U. S. NUCLEAR REGULATORY COMMISSION
OFFICE OF NUCLEAR REACTOR REGULATION

Licensee: Connecticut Yankee Atomic Power Company
P. O. Box 270
Hartford, Connecticut 06141

Facility Name: Haddam Neck Nuclear Power Plant
Audit At: Haddam Neck, Connecticut
Audit Conducted: July 24 - August 4, 1989

ISLOCA AUDIT REPORT

Figure 4.5 - LOW PRESSURE SAFETY INJECTION AND CORE DELUGE

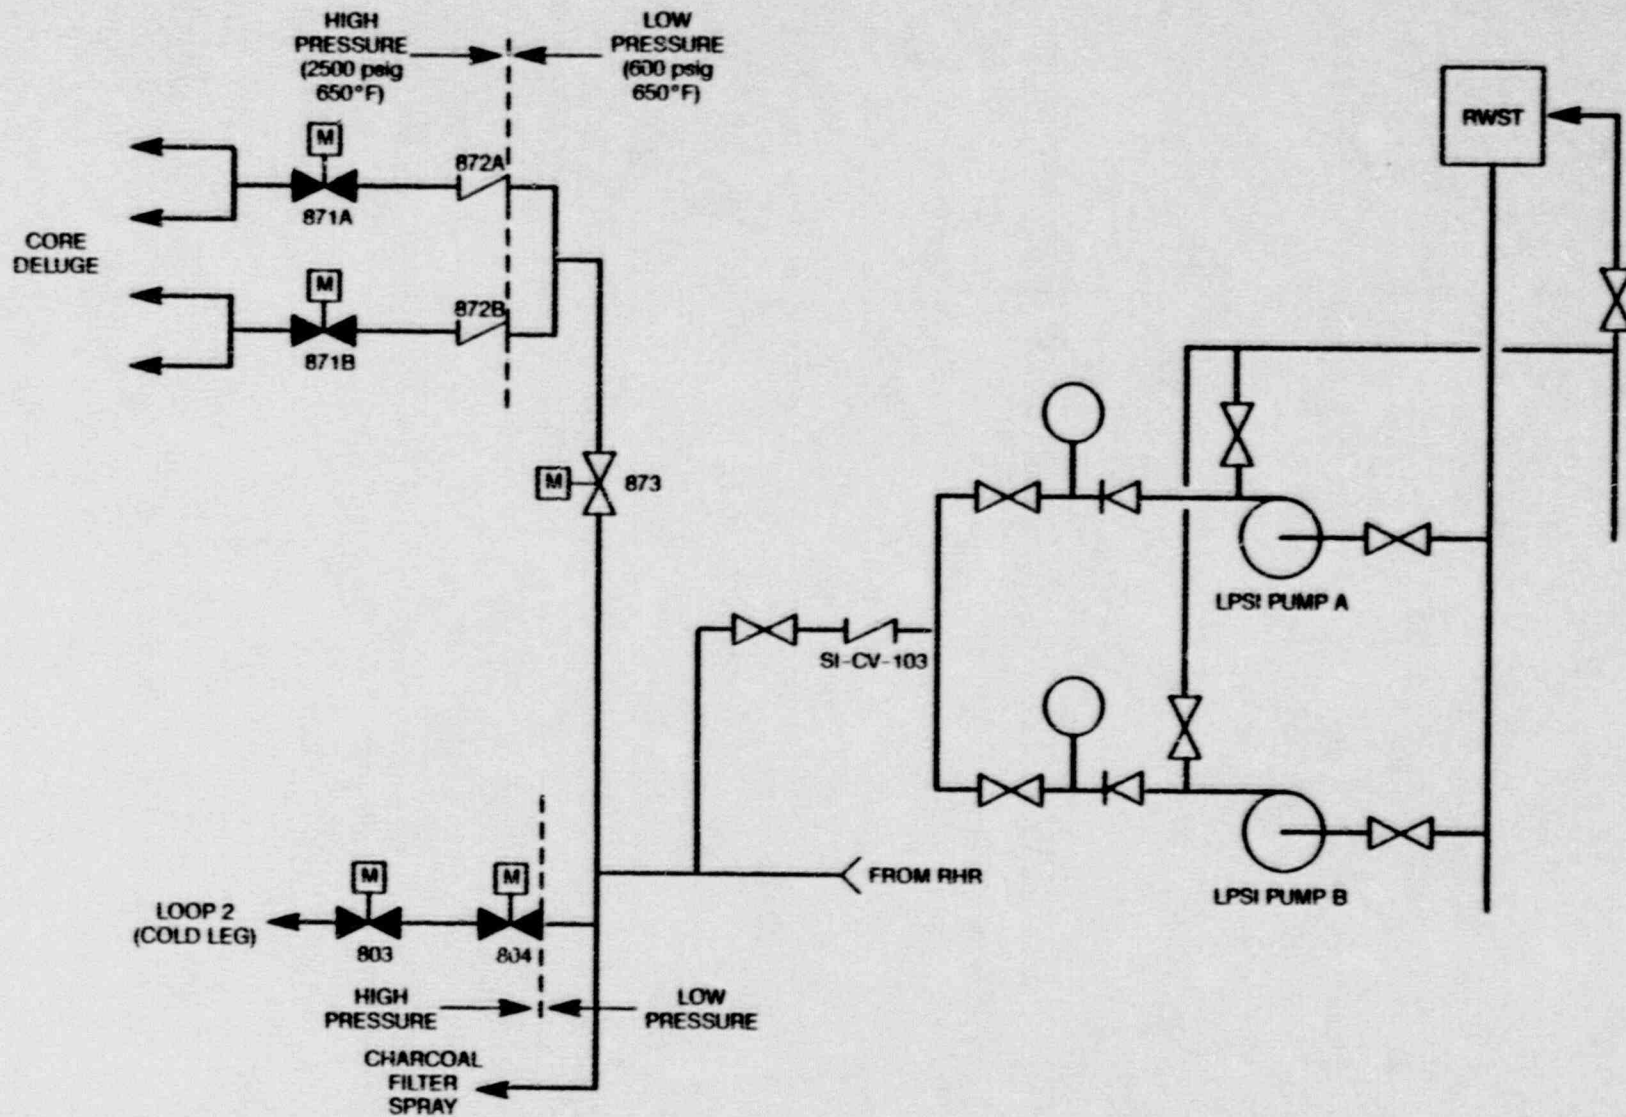
All interfacing low pressure lines have remote isolation capability with MOVs. However, actual closure of these valves after an ISLOCA event is questionable due to uncertainty of their capability to close under a high pressure gradient. The planned installation of an additional MOV on the low pressure deluge line may provide additional assurance of this lines isolation.

The isolation check valves are regularly leak tested. However, the inboard MOVs are only stroke tested to insure operability. The plant ISLOCA probabilistic risk analysis has indicated that the highest risk of an ISLOCA event is potential overpressurization events of the core deluge lines.

Figure 4.7 - SIMPLIFIED SCHEMATIC OF POTENTIAL PATHS FOR LOCA OUTSIDE CONTAINMENT IN THE CHEMICAL AND VOLUME CONTROL SYSTEM

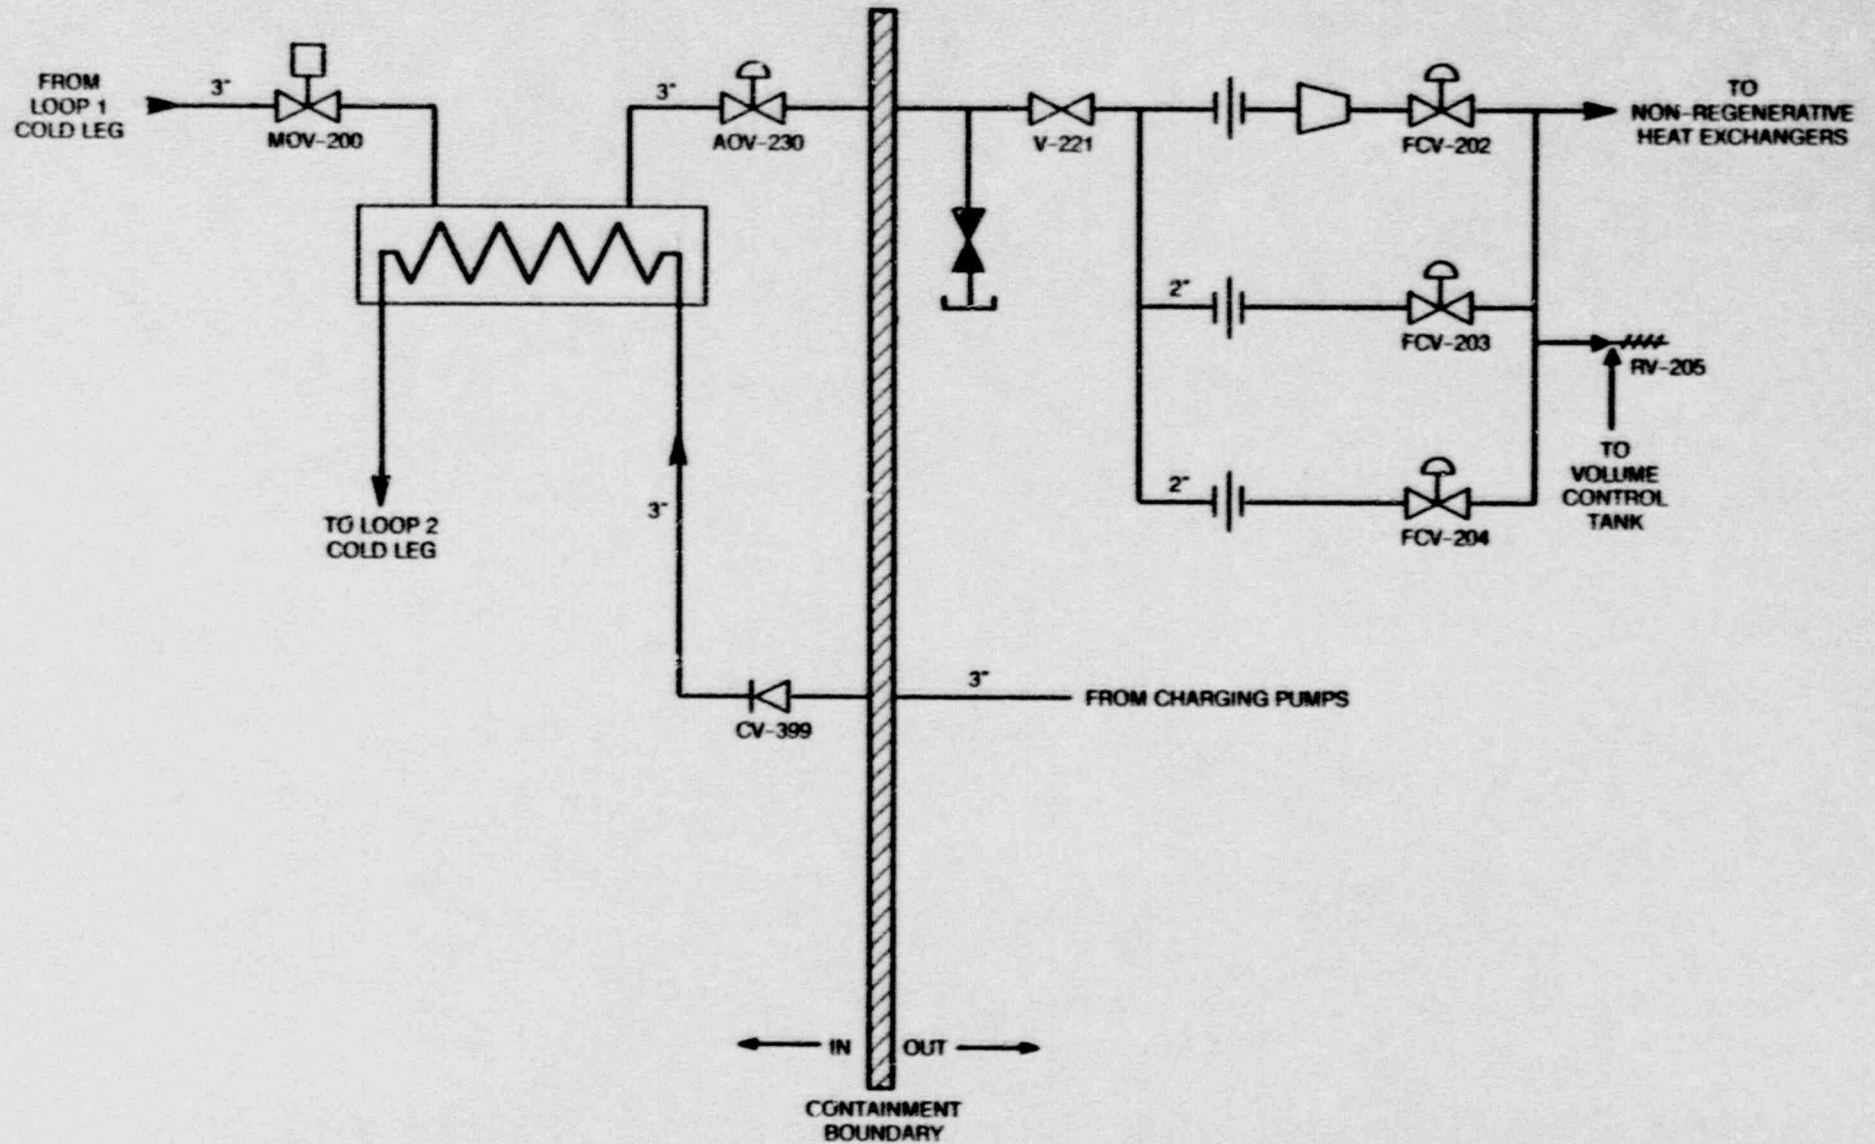
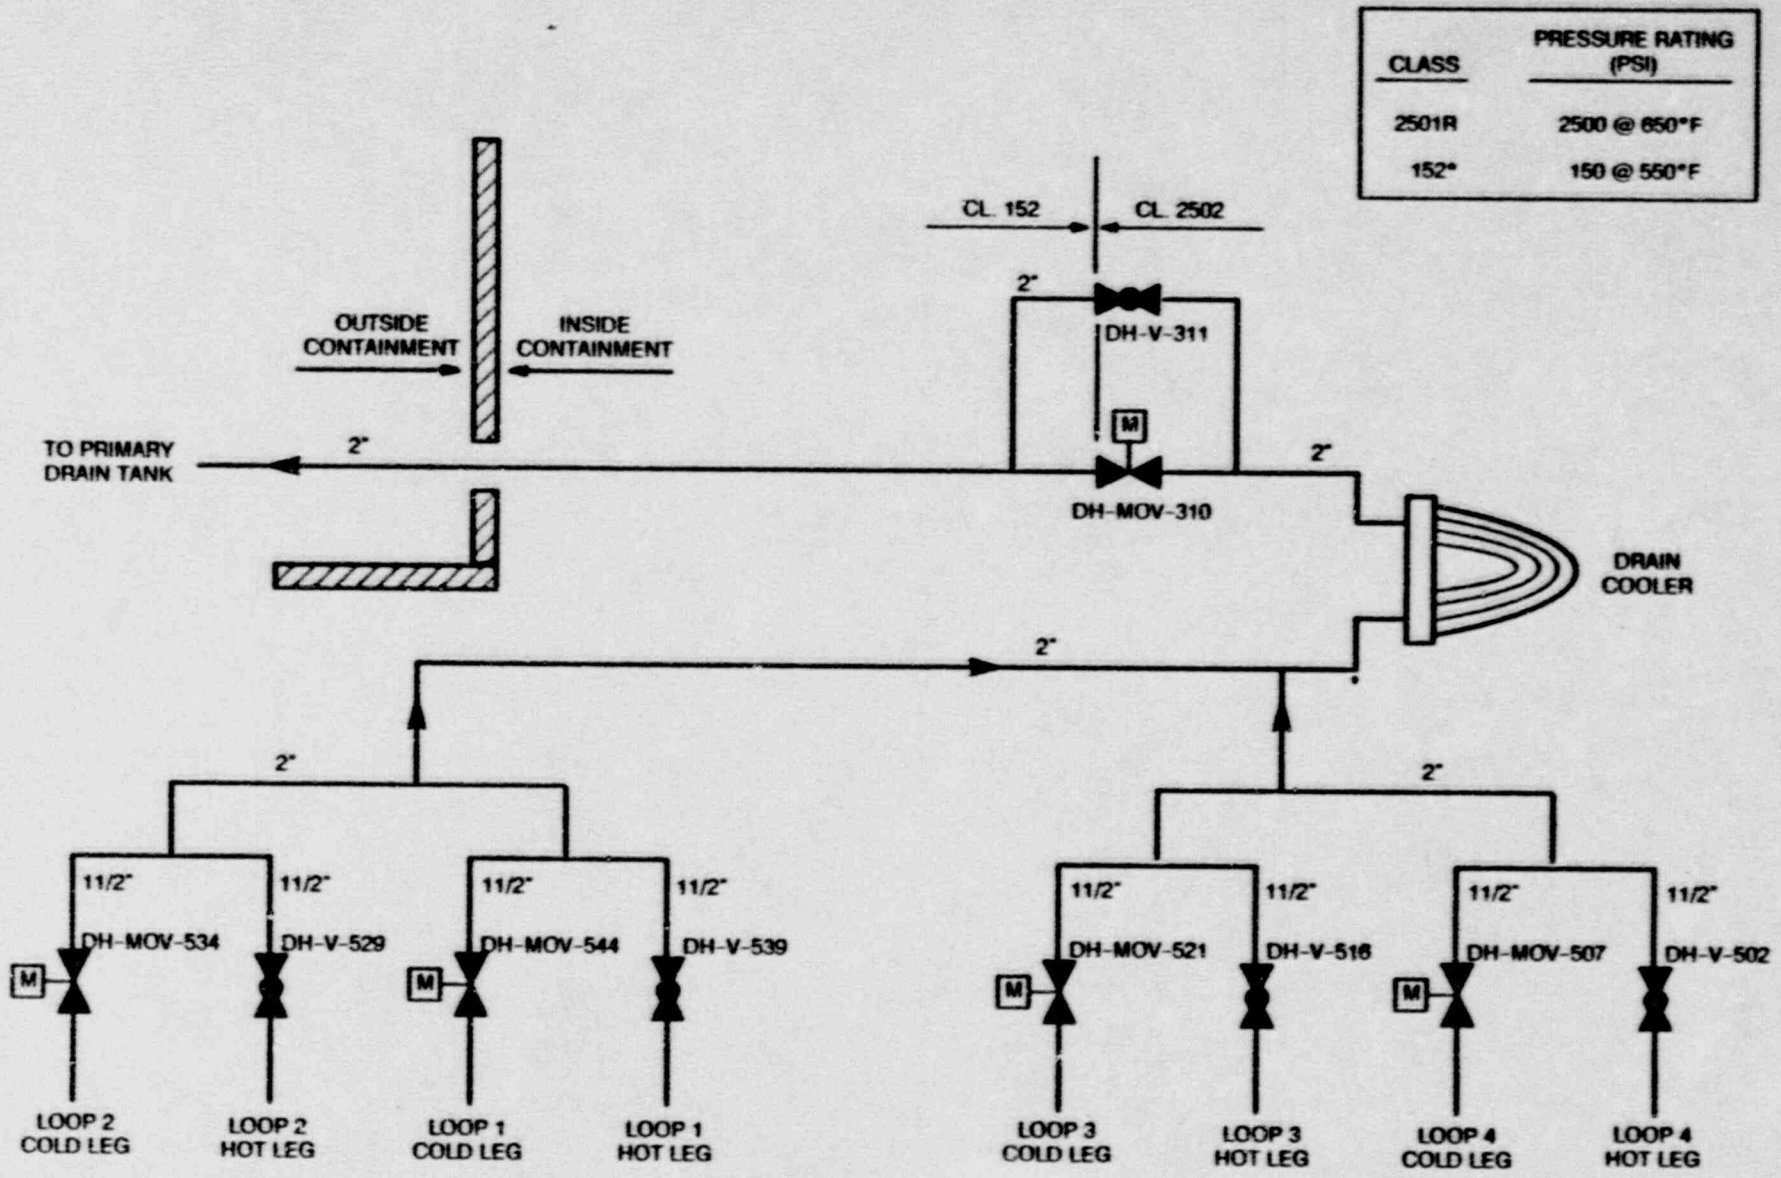
The Alternate Letdown system was designed to provide additional letdown capacity of RCS water-swelling during heatup/cooldown operations, and is normally isolated from RCS pressure during power operation. However, the cold leg MOV was routinely opened for a quarterly chemistry sampling, leaving DH-MOV-310 as the only pressure boundary valve.
